**Letter of Opposition
to Proposed Rezoning and Development RZ PD 22-0865
5500 Memorial Hwy, Tampa: Folio # 11994.0100**

The Dana Shores Civic Association (DSCA) **OPPOSES** the proposed rezoning and development RZ PD 22-0865 at 5500 Memorial Hwy and asks that the proposed PD ultimately be denied.

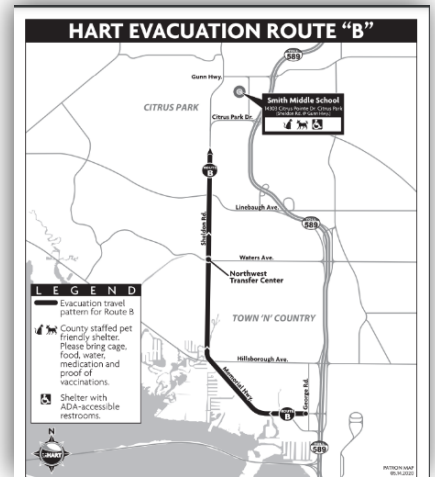
According to the 2020 Hillsborough County **Level of Service Report**, Memorial Highway was rated an “F” for its Daily Level of Service (LOS) and was already 7% beyond road capacity just west of the subject property. And, according to prior discussions with representatives of Hillsborough County’s Transportation Planning Organization (TPO), no plans exist to widen Memorial Highway.

The proposed development is also subject to the Hillsborough County Comprehensive Plan’s Commercial Locational Criteria per Policy 22.1-11. The nearest qualifying intersection is Dana Shores and Memorial Highway, which is over 1,000 linear feet away from the property.

Intensified use in conjunction with a waiver of the Commercial Locational Criteria Policy jeopardizes public safety on a day-to-day basis and is further intensified during a crisis.

The proposed PD is **INCONSISTENT** with current roadway conditions and HILLSBOROUGH COUNTY COMPREHENSIVE PLAN, Commercial Locational Criteria Policy 22.1-11.
